**ITEM #5 - PRELIMINARY PLAT  
TOWNSITE OF KASILOF PREE REPLAT**

<b>KPB File No.</b>	2023-117
<b>Plat Committee Meeting:</b>	November 13, 2023
<b>Applicant / Owner:</b>	Jon David Pree / Visalia, CA Kenai Peninsula Borough / Kenai, AK
<b>Surveyor:</b>	Mark Aimonetti / Edge Survey and Design, LLC
<b>General Location:</b>	Old Town Kasilof / Kasilof area

**STAFF REPORT**

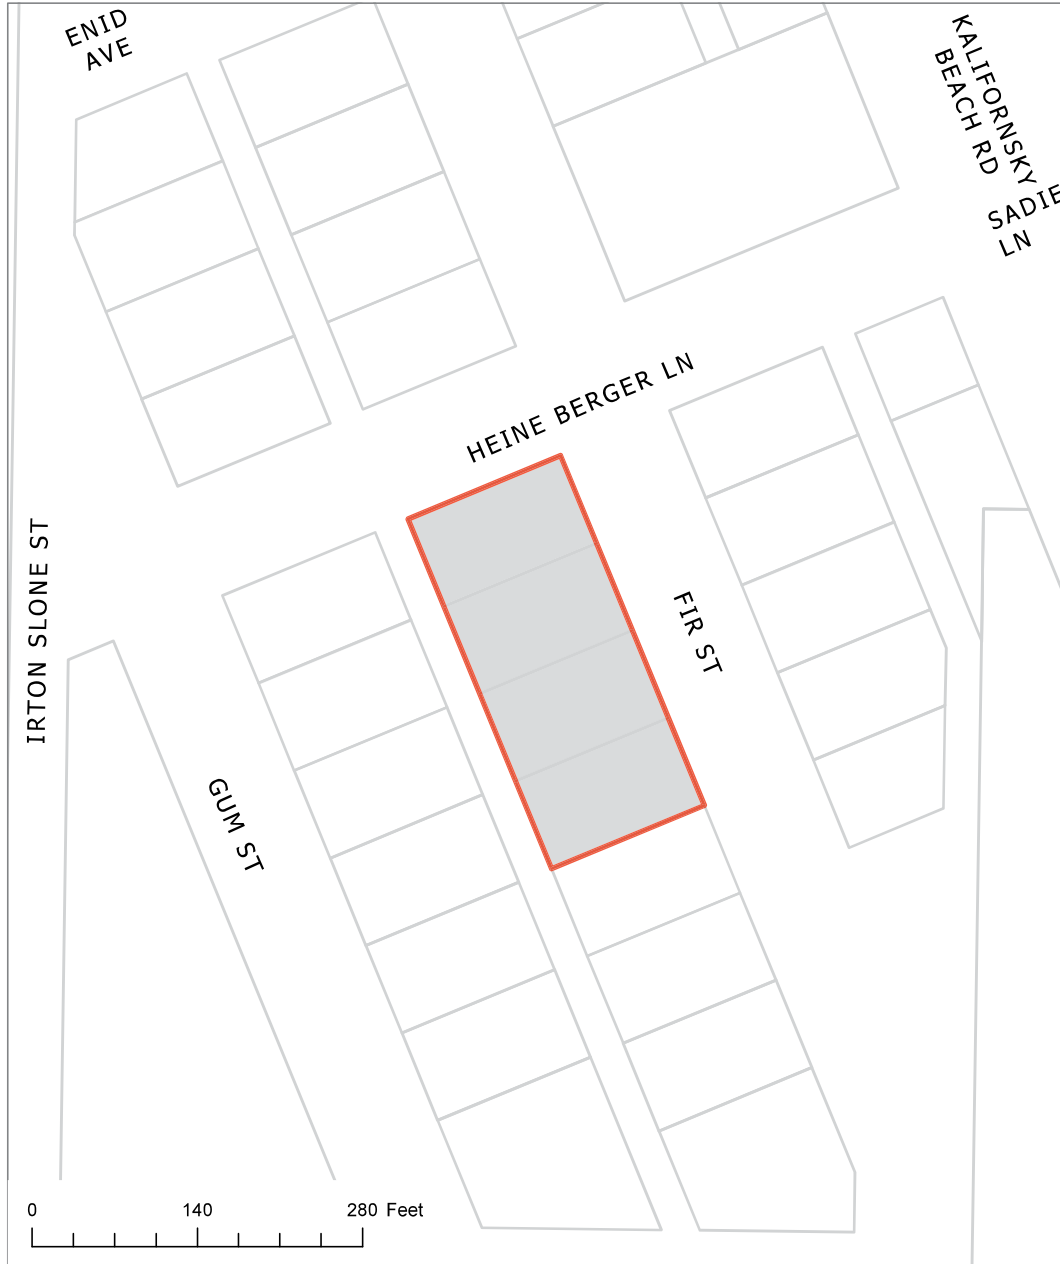
- Add KPB No 2023-117

**Staff recommendation:**
- Correct name of Heine Berger Lane to the north
- D. A vicinity map, drawn to scale showing location of proposed subdivision, north arrow if different from plat orientation, township and range, section lines, roads, political boundaries, and prominent natural and manmade features, such as shorelines or streams;

**Staff recommendation:**
- Blacken area representing the subdivision
- G. The status of adjacent lands within 100 feet of the proposed subdivision boundary or the land status across from any dedicated rights-of-way that adjoin the propose subdivision boundary, including names of subdivisions, lot lines, block numbers, lot numbers, rights-of-way; or an indication that the adjacent land is not subdivided;

**Staff recommendation:**
- Lots to the east need correct lot numbers listed.
  - Add Lot 6 Block 12 label to the east.
